Design review report

Code: AE-32846

Aim of this document is to describe suggestions and corrections that Telit advises to improve **Ovoo Electronics "B106AA(V2)"** application that integrates Telit module **GE910-QUAD V3**.

2.1.3. Digital pins

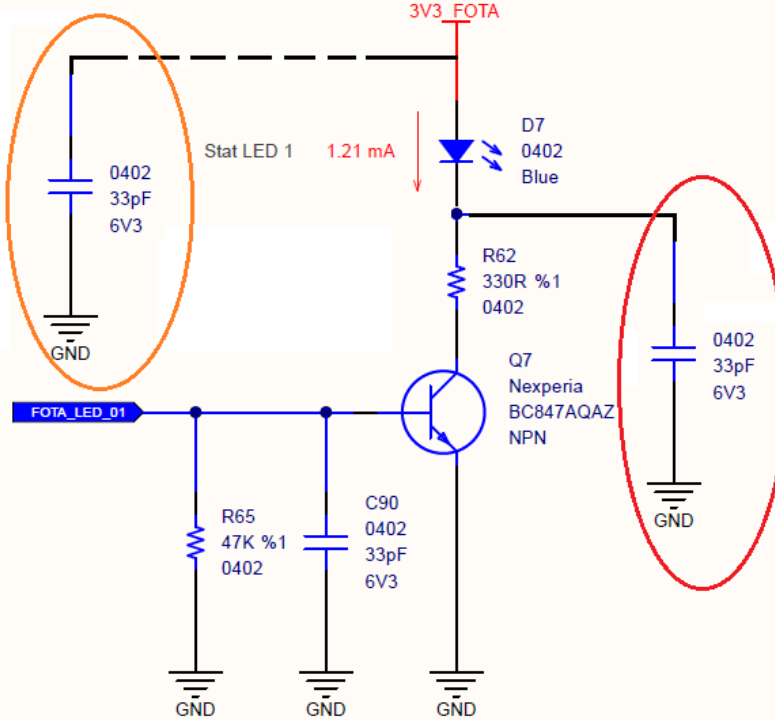
- ⚠ For testing purposes it could be useful having direct access to the modem from external, with the host MCU isolated. USB is not implemented on GE910-QUAD V3 so we strongly suggest adding test points and/or 0R series resistors on Main-UART lines and wherever needed (e.g. OE control line of level shifter U4) in order to made Main UART accessible.
